January 16, 2025

ADDENDUM #4

Coastal Carolina Community College
Learning Resources Center
First Floor Renovation
SCO ID: 23-26060-01A

Sheet No.
A5.0
Addendum #4, Attachment #3

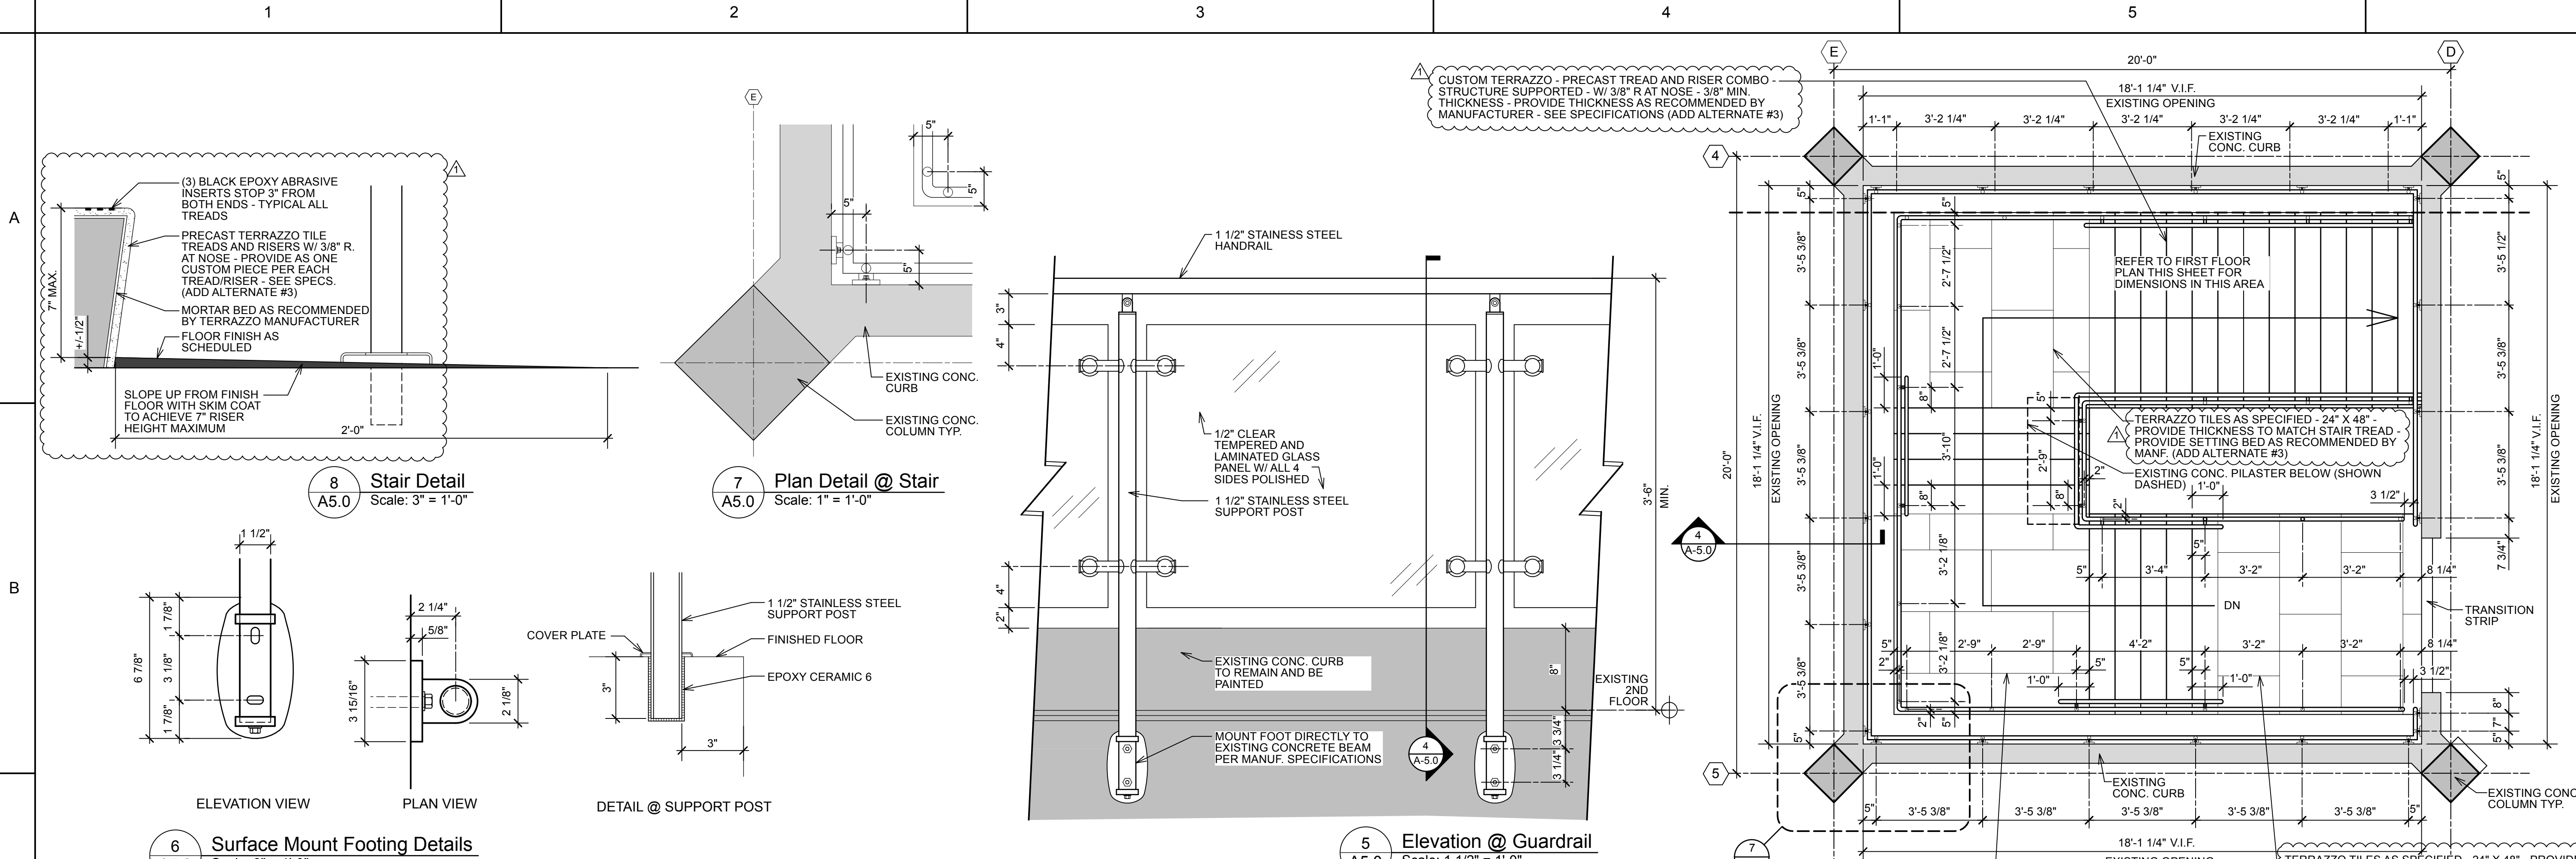
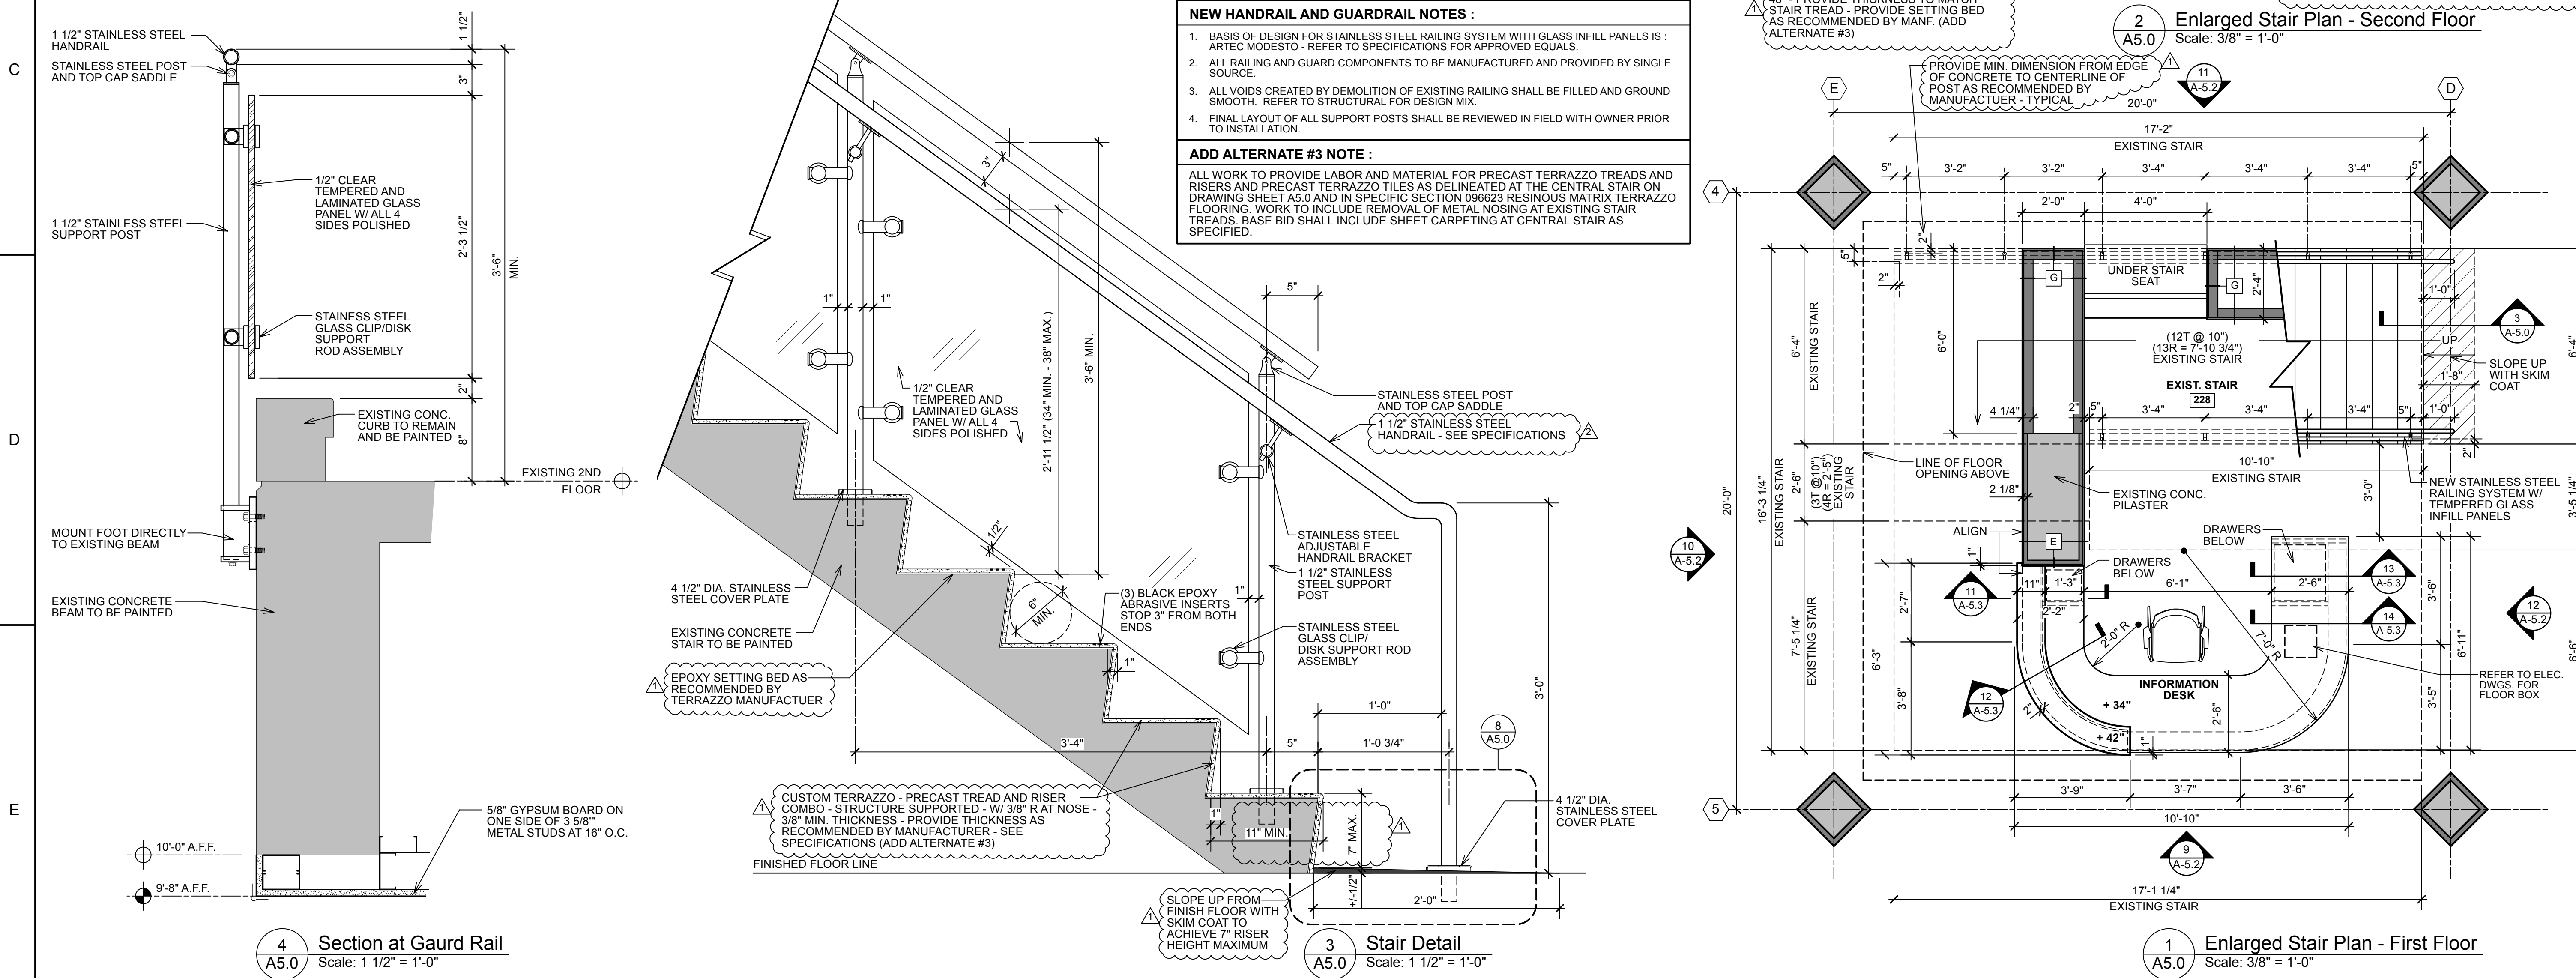
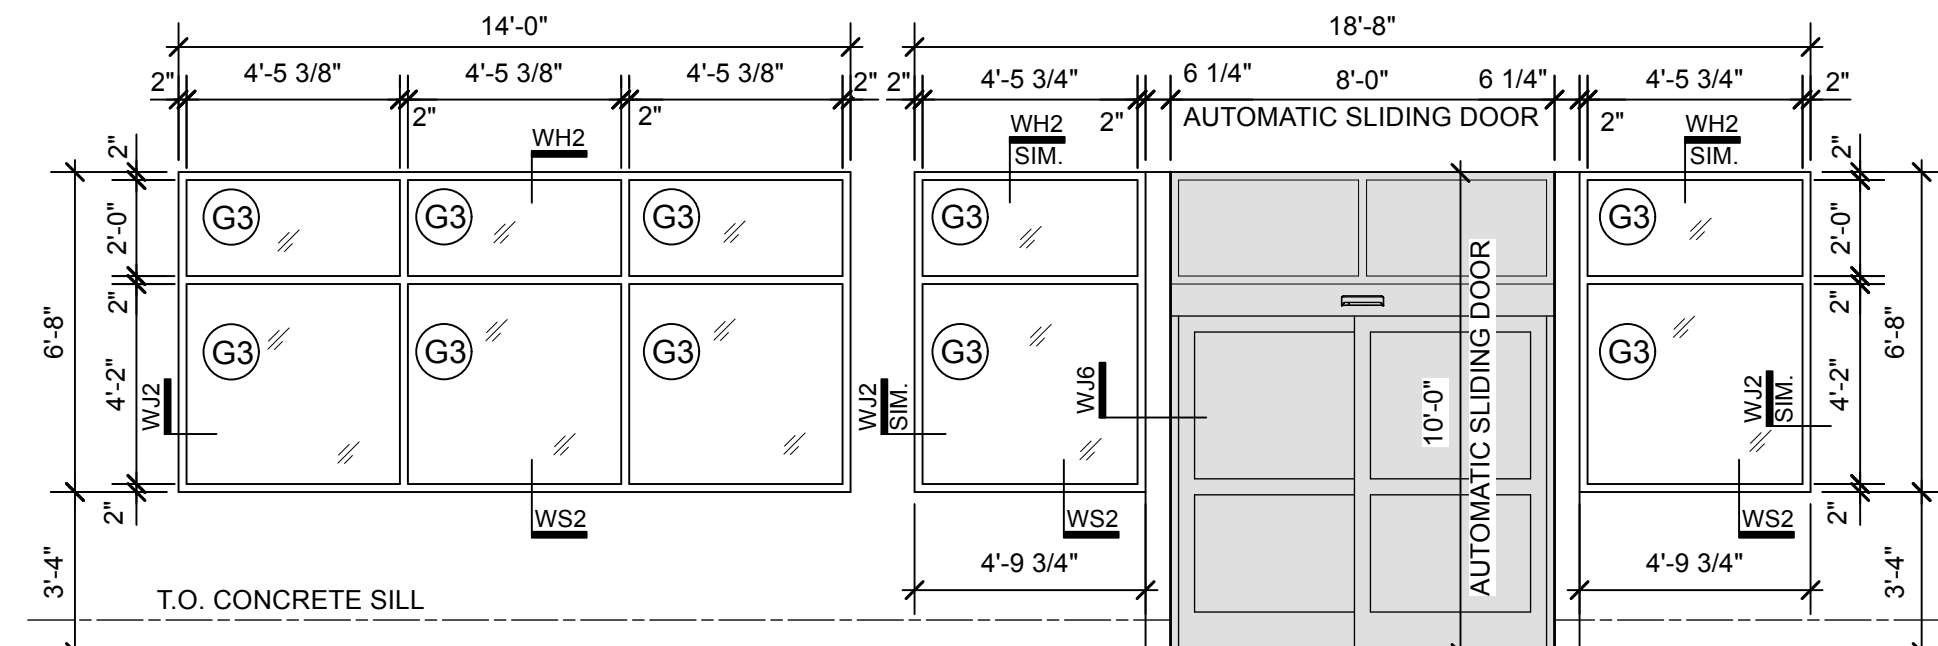
A note on drawing 3/A5.0 incorrectly calls out a ‘1 ½” Aluminum Handrail’, this note has been revised to clarify the handrail is stainless steel. Revised drawing sheet A5.0 is included as **Attachment #3**.

ALL WORK TO PROVIDE LABOR AND MATERIAL FOR PRECAST TERRAZZO TREADS AND RISERS AND PRECAST TERRAZZO TILES AS DELINEATED AT THE CENTRAL STAIR ON DRAWING SHEET A5.0 AND IN SPECIFIC SECTION 096623 RESINOUS MATRIX TERRAZZO FLOORING. WORK TO INCLUDE REMOVAL OF METAL NOSING AT EXISTING STAIR TREADS. BASE BID SHALL INCLUDE SHEET CARPETING AT CENTRAL STAIR AS SPECIFIED.

Sheet No. **A6.1**
 Addendum #4, Attachment #4

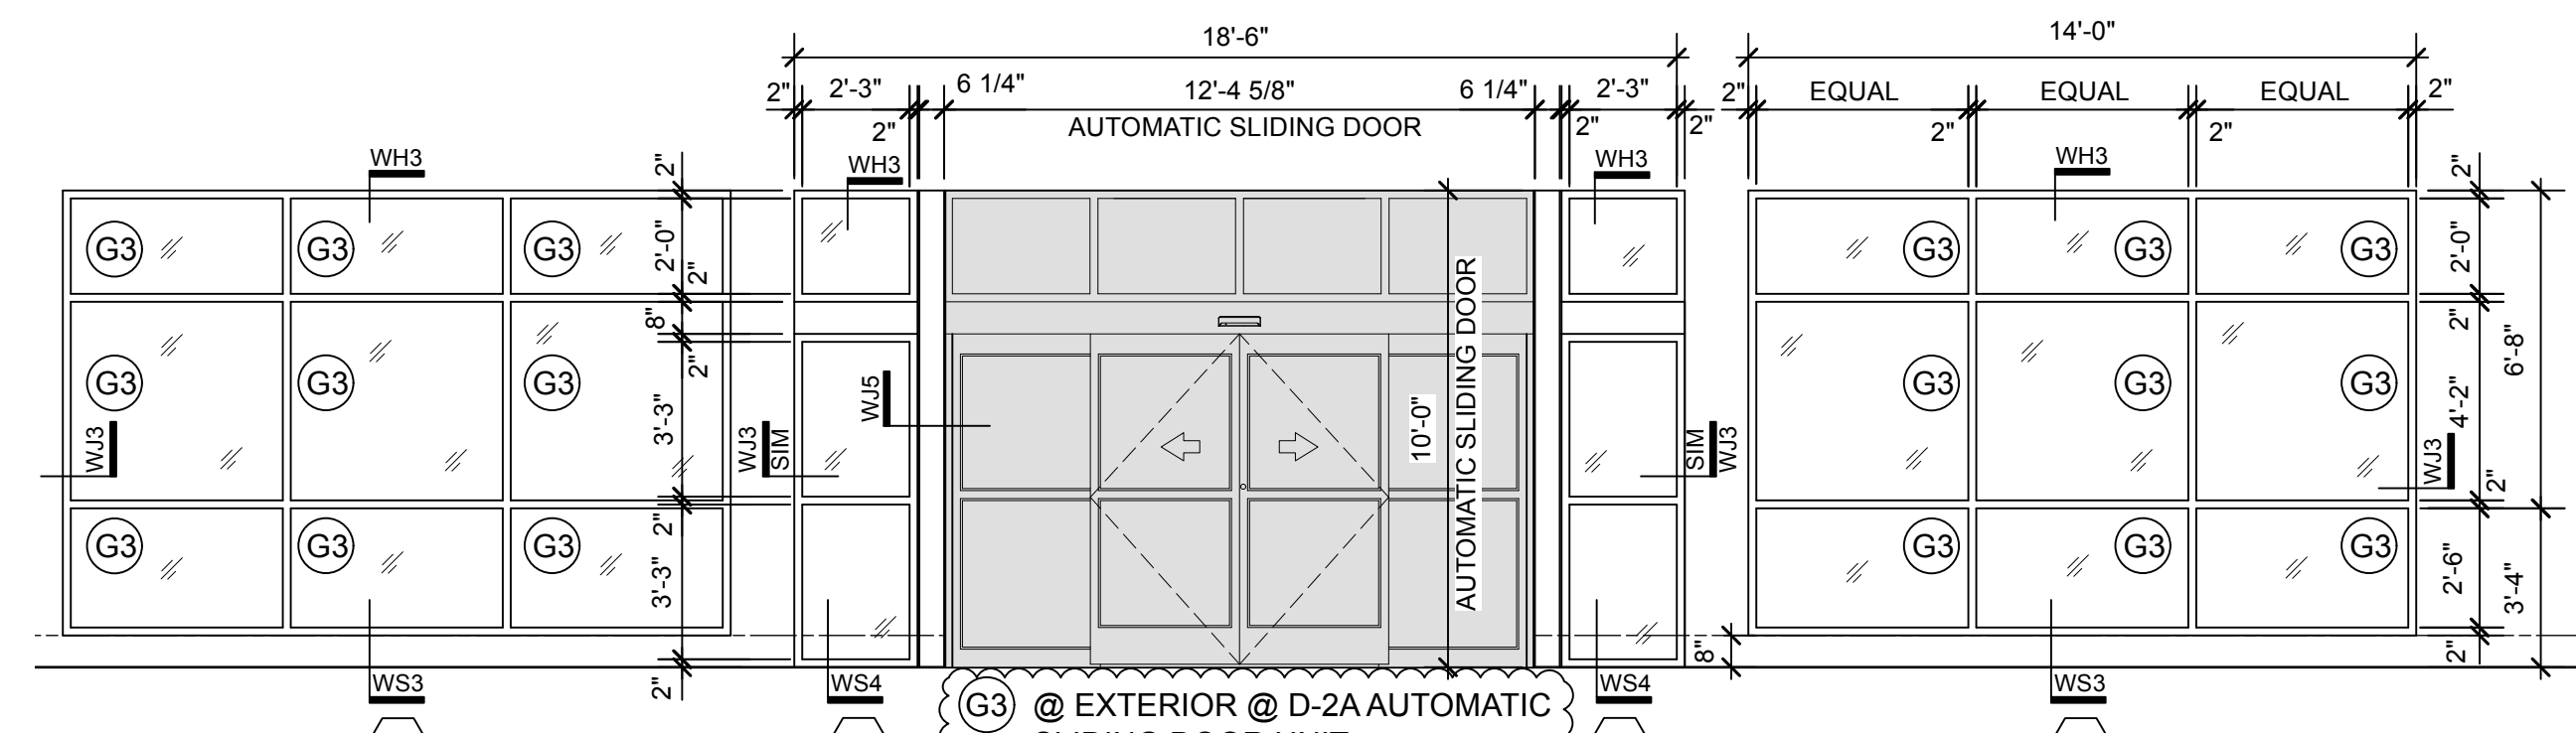
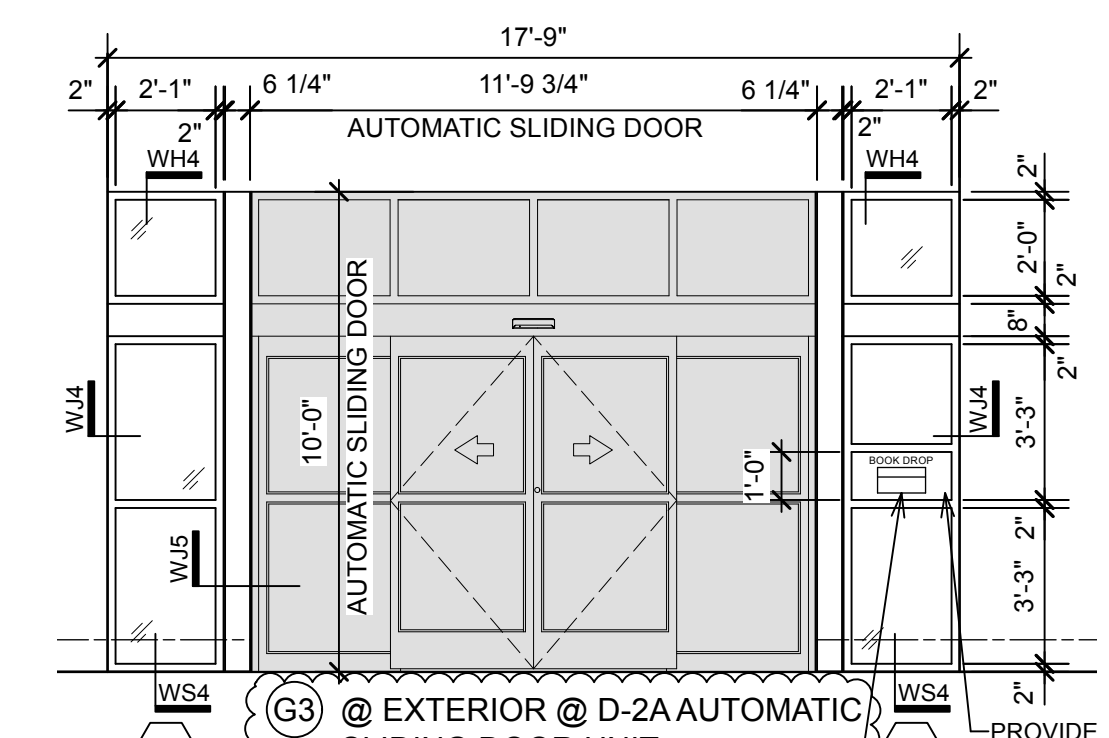
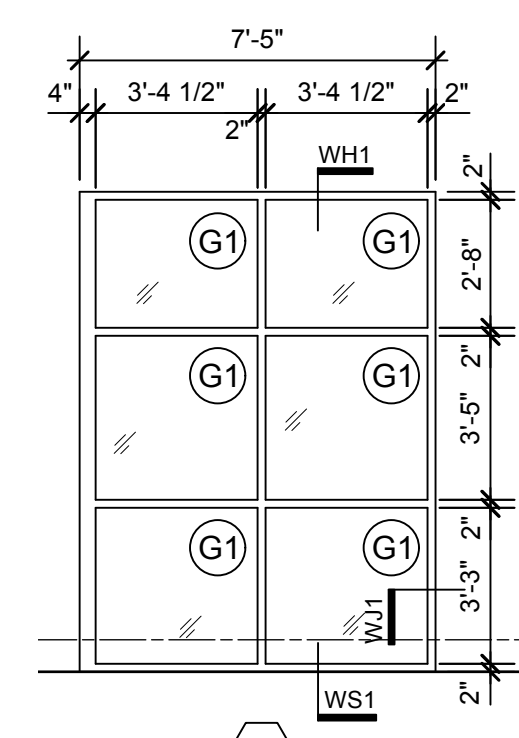
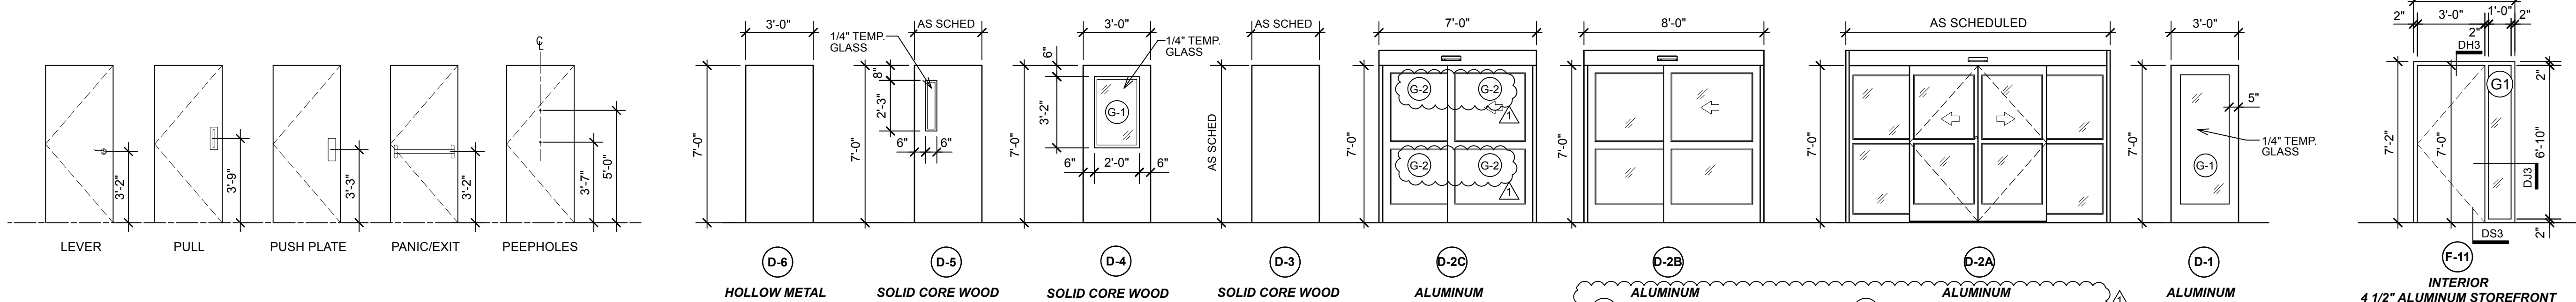
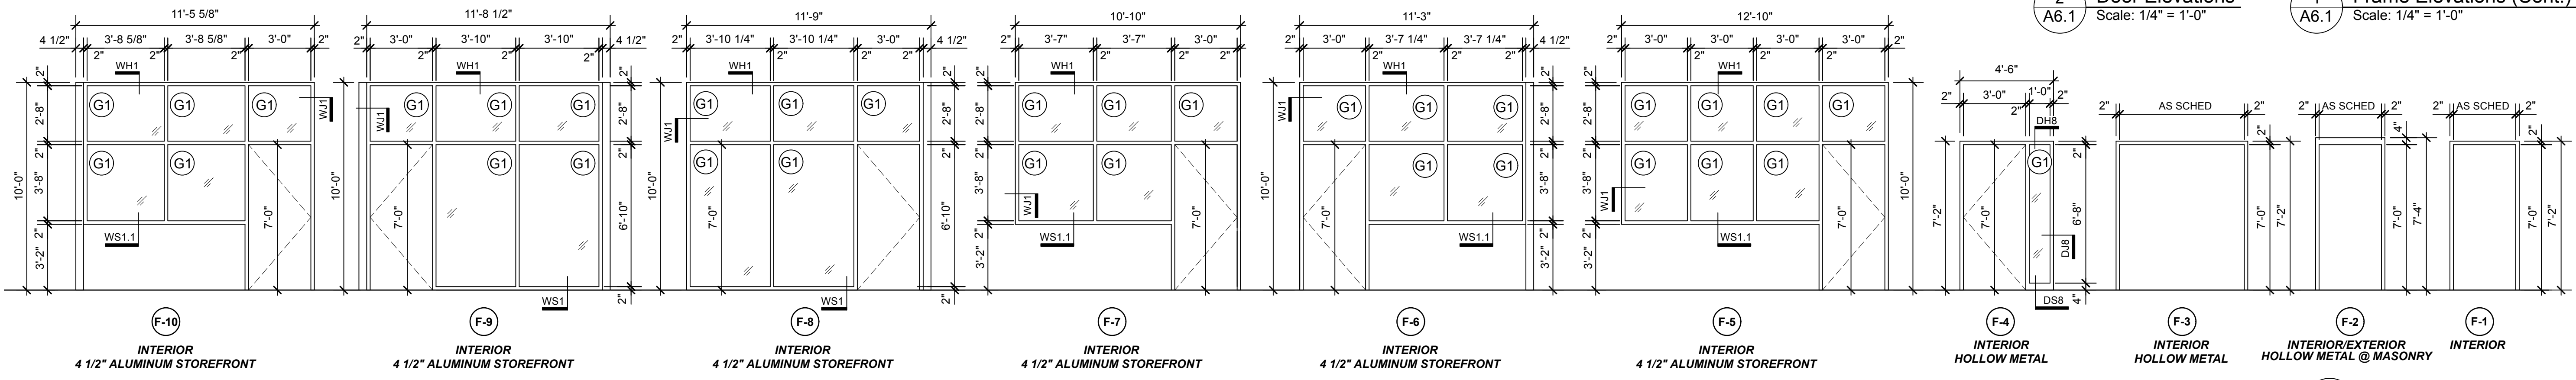
Notations have been added to clarify the glazing at the automatic sliding door units. Notations have been added to Window Elevation W-3 to clarify aluminum storefront framing requirements at this location. Revised drawing sheet A6.1 is included as **Attachment #4**.

G3 @ EXTERIOR @ D-2B AUTOMATIC SLIDING DOOR UNIT
 G2 @ INTERIOR @ D-2B AUTOMATIC SLIDING DOOR UNIT

NOTE @ W-3: PROVIDE MEDIUM WEIGHT STOREFRONT VERTICALS OR OTHER PROVISIONS AS REQUIRED BY MANUFACTURER TO RESIST WIND PRESSURES AS INDICATED ON STRUCTURAL DRAWINGS.
